GRCA Agency Review Document Book

GRCA Agency Review Document Book Index

**RE: Application for Zoning By-Law Amendment
8352 Highway 7
Part lot 1, Concession 6, Township of Guelph/Eramosa
634745 Ontario Limited / James Dick Construction Limited**

**Re: Response to GRCA comments regarding Hidden Quarry
Guelph-Eramosa File ZBA09/2012
Cumulative Effects Assessment Issues**

Figure 2: Tributary B Catchment Area

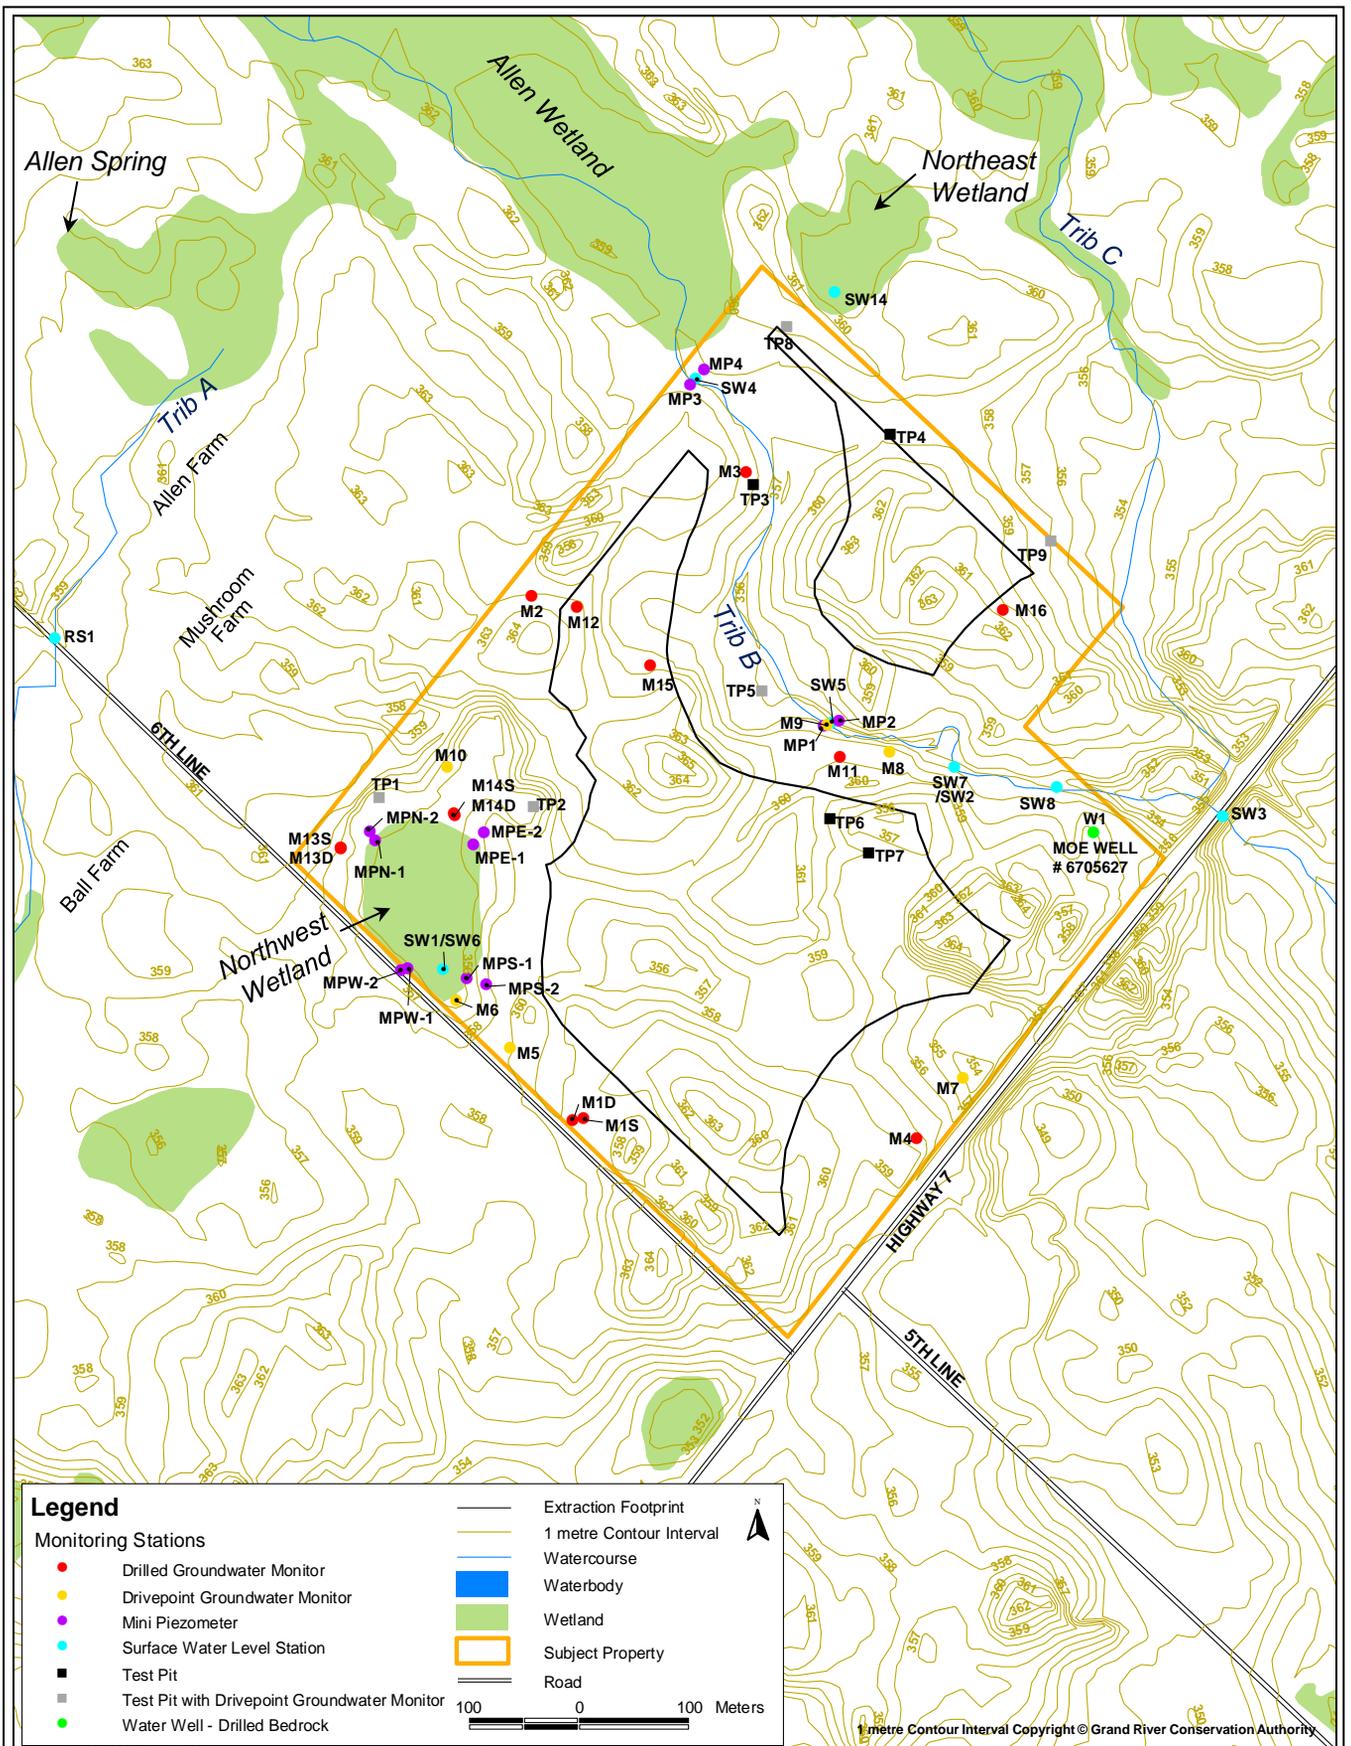
The total catchment area of Tributary B upstream from the southern edge of the proposed quarry is 585,156 m² (Figure 2). The catchment area reduction of 19,095 m² represents 3.3 percent of the total catchment area and will not significantly affect the hydrological function of the stream.

HARDEN ENVIRONMENTAL	
Figure 3.20: Simplified Geologic Cross-Section	
DATE: Feb 2012	SCALE: As Shown
PROJECT: 1036	DRAWN BY: AV

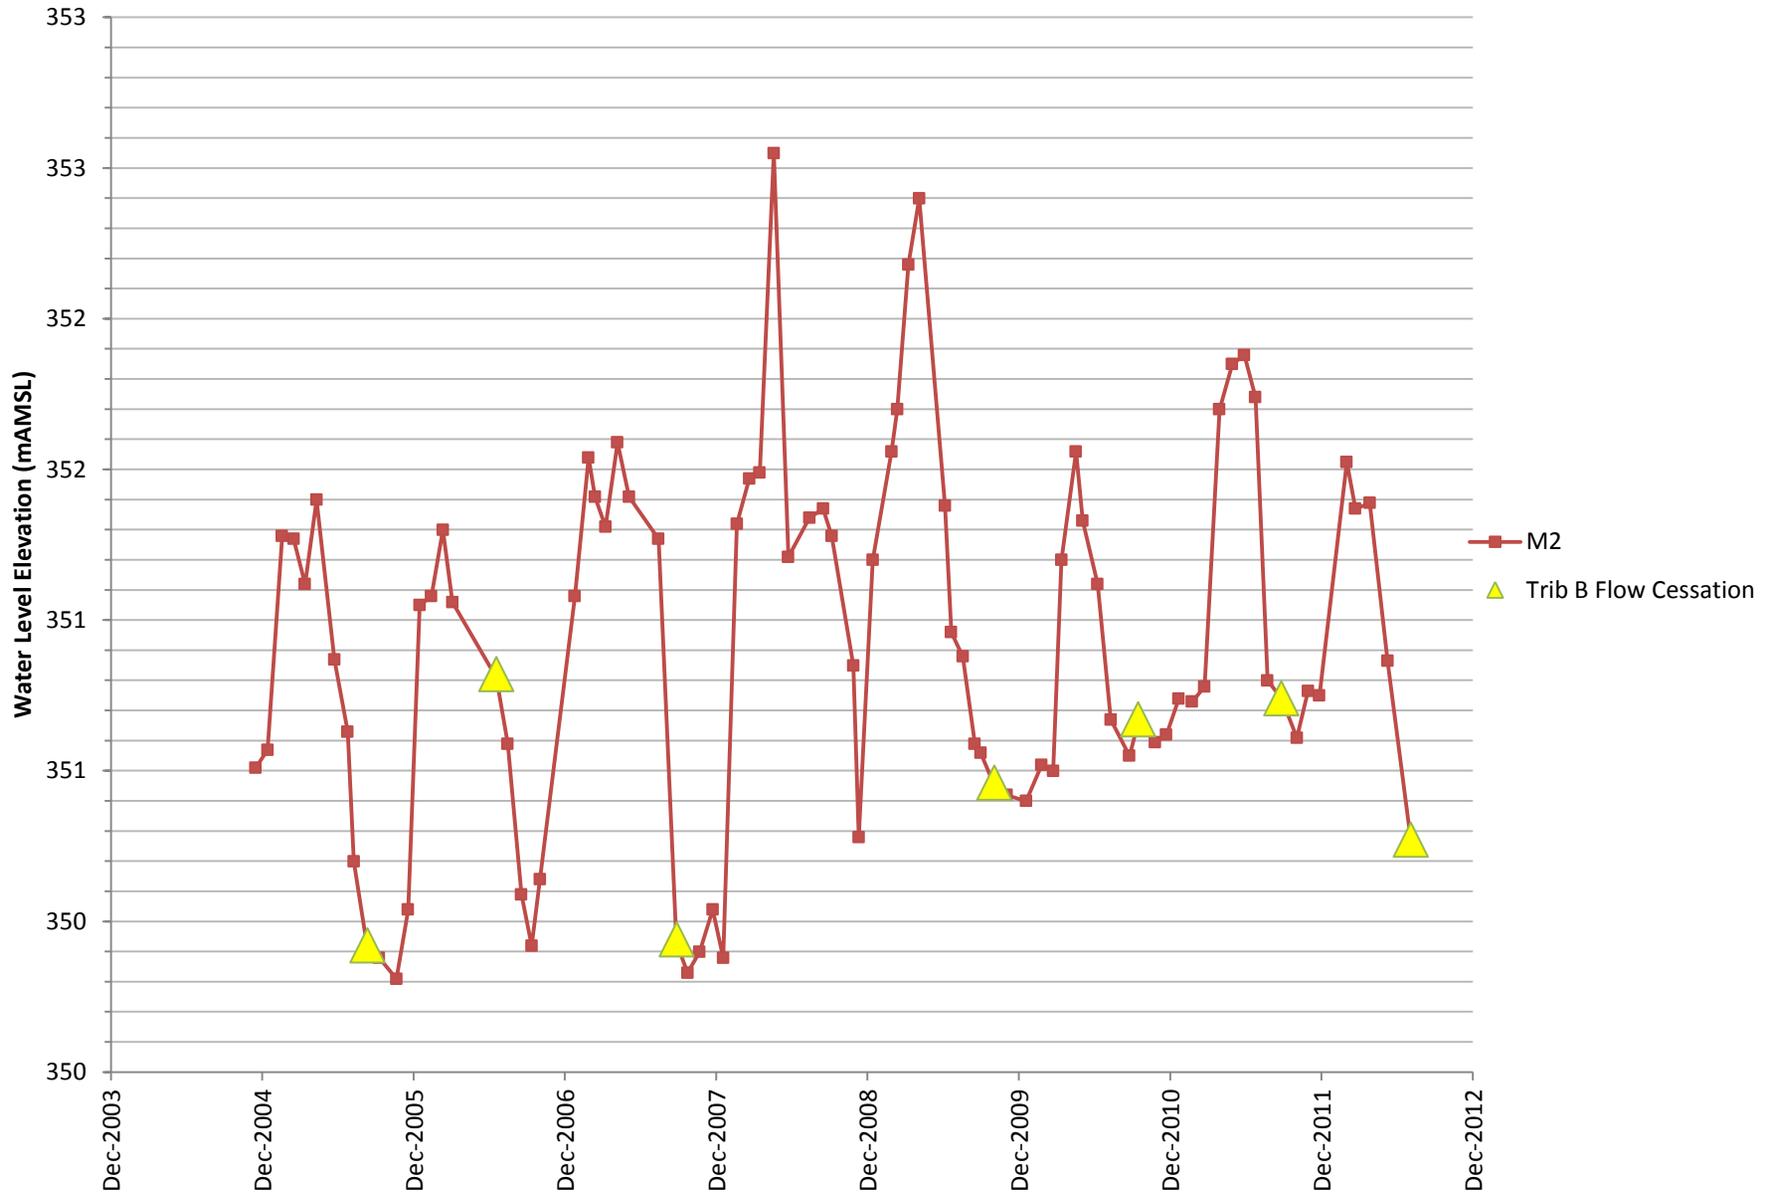
With respect to potential groundwater contributions, we have attached Figure 3.20 from our original December 2012 report. This is a cross section through the Allen Wetland (location shown on Figure 2). It can be seen that it is not possible for groundwater to contribute to the wetland given the superior elevation of the wetland compared to low ground elevations to the east and west. Ground elevations to the south also decrease. In addition, the nearest groundwater monitors being M2 (bedrock) and TP8 (overburden) on

Figure 5: Trib B Flow Cessation and M2 Groundwater Levels

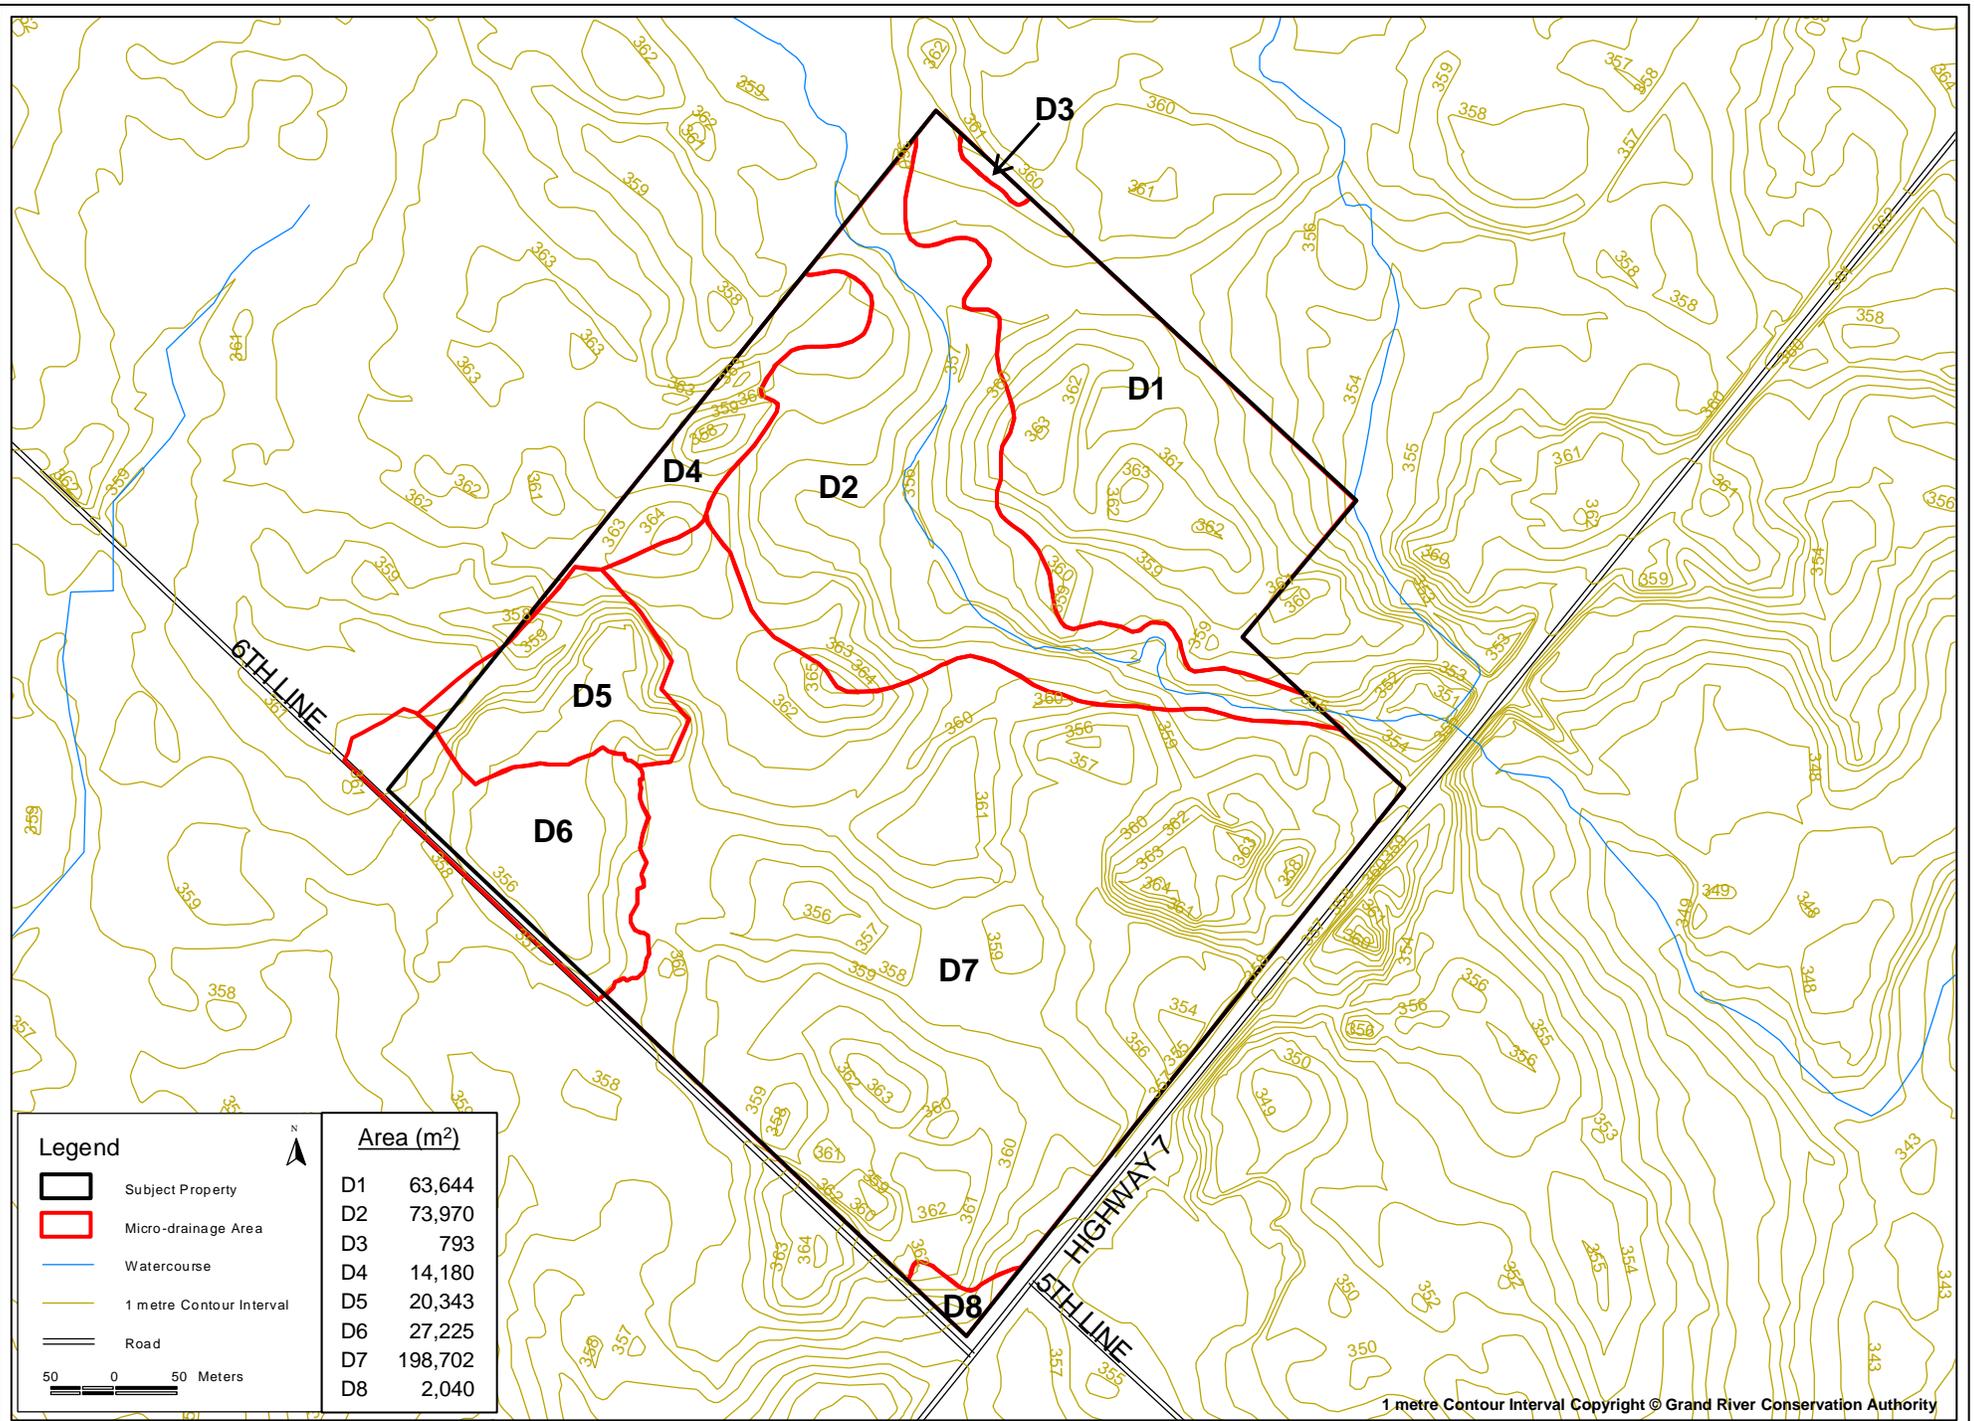
It is our opinion that the bedrock groundwater levels are not associated with the hydro-period of the wetland. Figure 5 shows the date that Tributary B was first observed to be dry (on an annual basis) compared to the bedrock groundwater level on that date as observed in groundwater monitor M2. If bedrock groundwater levels were a significant influence on wetland conditions, one would find that the creek would dry up when groundwater was below a certain elevation. Figure 5 shows that Tributary B becomes dry over a wide range of bedrock ground water levels, suggesting other factors determine streamflow (e.g. antecedent rainfall, storage in the De Grandis ponds).

Figure 7: Northwest Wetland Hydrograph

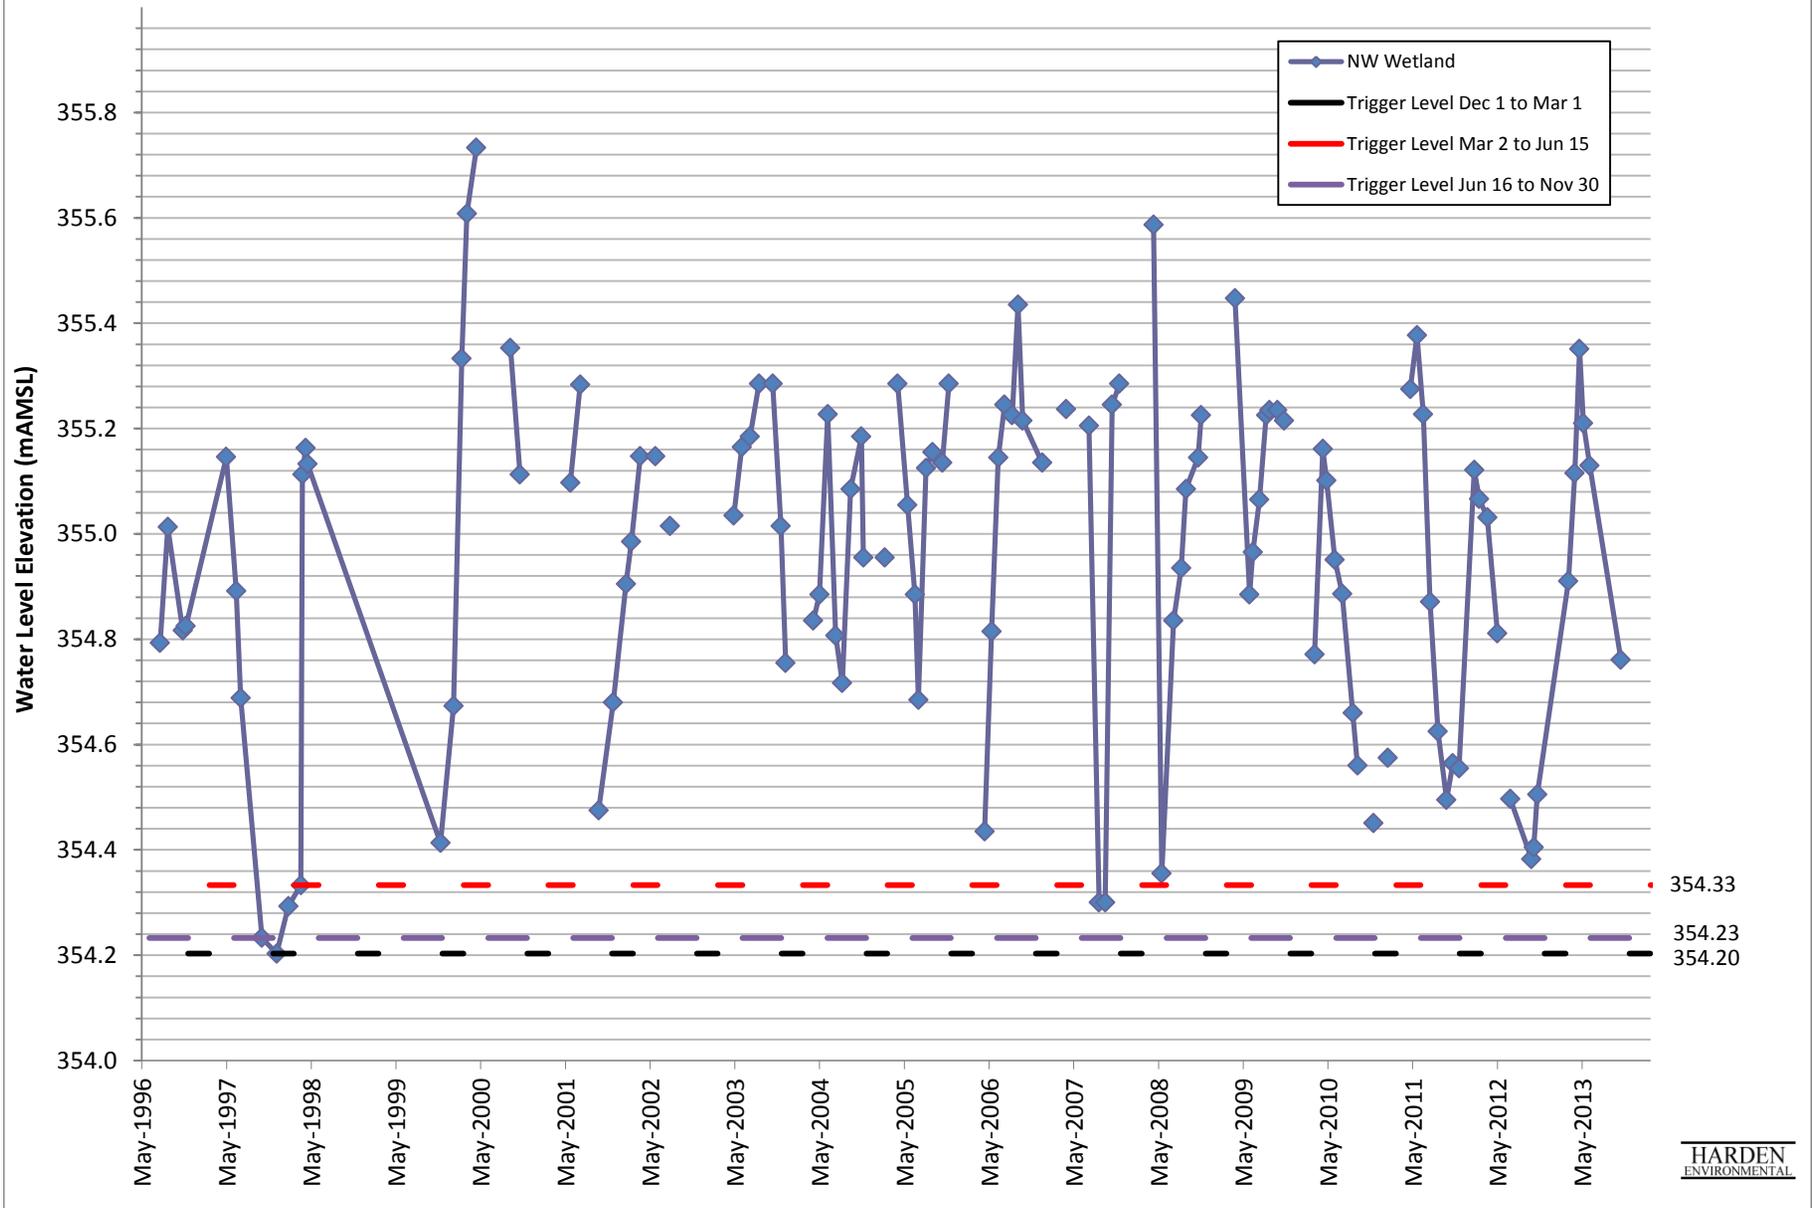
We have attached a hydrograph with proposed seasonal trigger levels (Figure 7) for the Northwest Wetland. We are recommending three trigger levels, winter, spring and summer/fall. The trigger levels have been assigned as follows;
